Subject: ACEH SCP Case File RO470
Addendum to Post-Construction Work Plan
Former APL Terminal, Port of Oakland
Berths 60-63 Redevelopment Project
1395 Middle Harbor Road, Oakland, CA

Subject: Addendum to Post-Construction Work Plan
Former APL Terminal, Port of Oakland
Oakland, California

The following provides ACEH technical comments and a description of additional sampling, analyses, or clarification to address ACEH comments on the Work Plan and changes to boring locations based on results of utility clearance findings.

PROPOSED BORING LOCATIONS – CASES 002 AND 010
 Post-Construction Work Plan
 Former APL Terminal, Port of Oakland
 Oakland, California

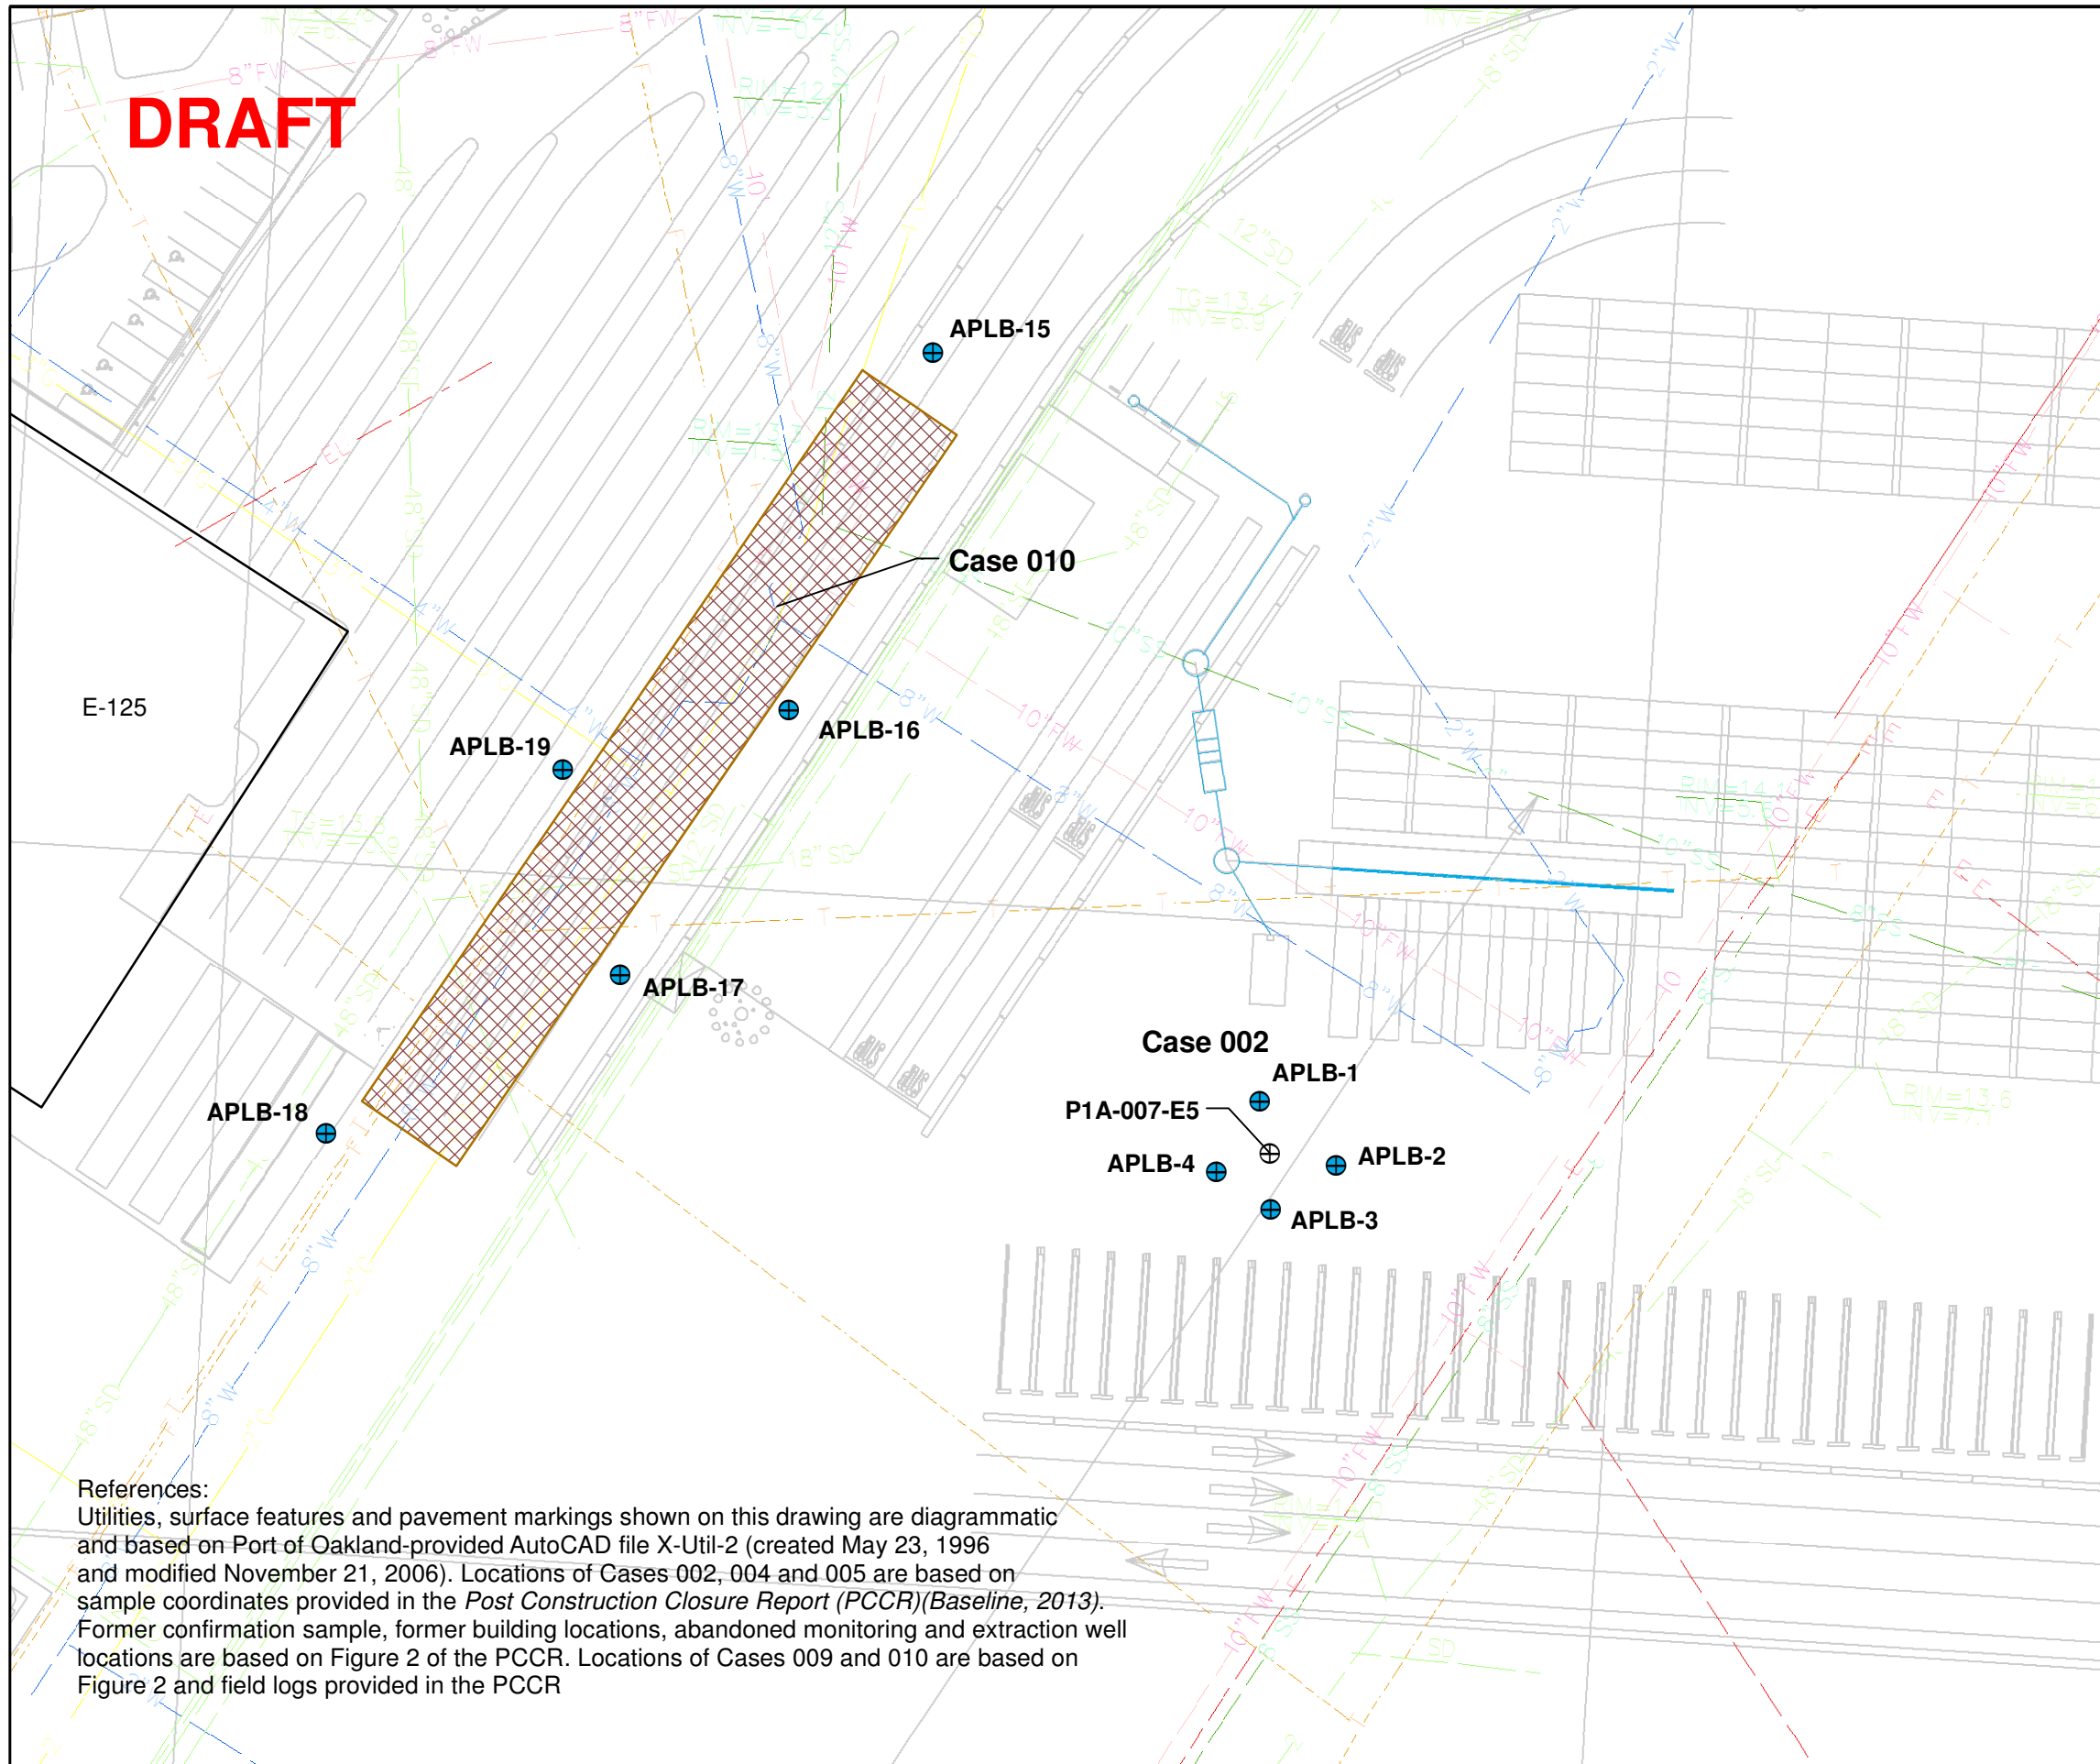
ACEH request that an additional soil boring be advanced to the west of the Case 010 trench location in order to define the lateral extents of contamination. Please locate the boring opposite the mid-point between APLB-16 and APLB-17 shown on Figure 3 of the Work Plan.

ACEH requests that an additional soil boring be advanced to the west of the Case 010 trench location in order to define the lateral extents of contamination. Please locate the boring opposite the mid-point between APLB-16 and APLB-17 shown on Figure 3 of the Work Plan.

Response: One additional boring, APLB-19, will be drilled and sampled at a location northwest of the former Case 010 trench. Soil samples will be collected as described above. A grab groundwater sample will also be collected from the additional boring for chemical analysis. Revised Figure 3 (attached) shows the new boring location and Table 1 (attached) has been revised to list samples that will be collected from that additional boring.

- B-16: Moved approximately 2.5 feet northwest
- B-18: Moved approximately 4.5 feet east
